## ADDENDUM NO. 2

**Date:** March 1, 2019

**Project:** BABLO Roof Replacement  
10 Water Street  
Hallowell, Maine

**1 TYP EPDM ROOF SYSTEM**  
AE501 SCALE: 3"=1'-0"  
AE120

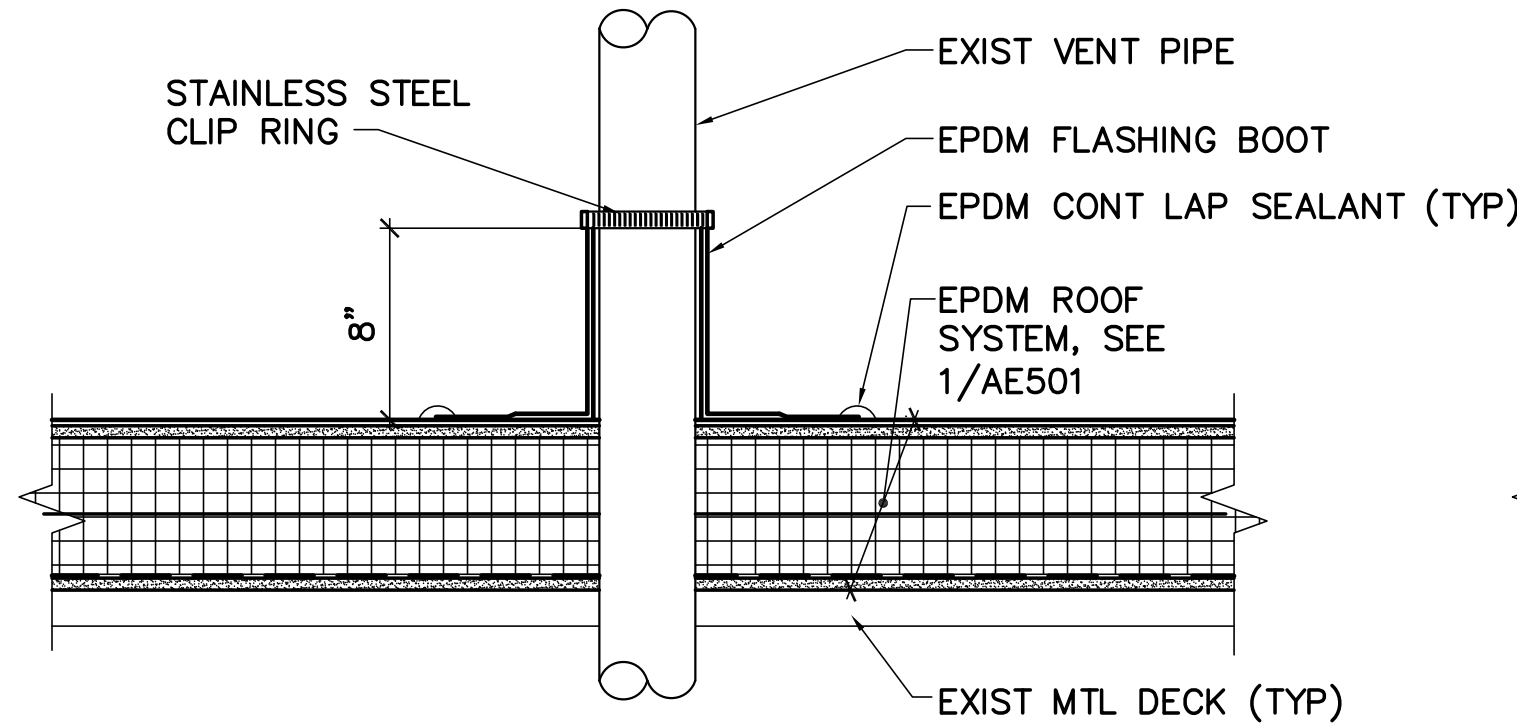
**Question:** *Are tapered insulation crickets required on this project over the 6" of base insulation for proper drainage or does the whole roof system need to be fully tapered over the 6" base layers of insulation?*

Question: Is the intention to install 2-layers of 3" polyiso or a 3" base with tapered installed on top of that.

Response: Refer to attached revised roof plan and detail sheets. Design intent is to provide minimum average R-30 insulation value for the new roof.

Response: Refer to attached revised roof plan and detail sheets. Design intent is to provide minimum average R-30 insulation value for the new roof.
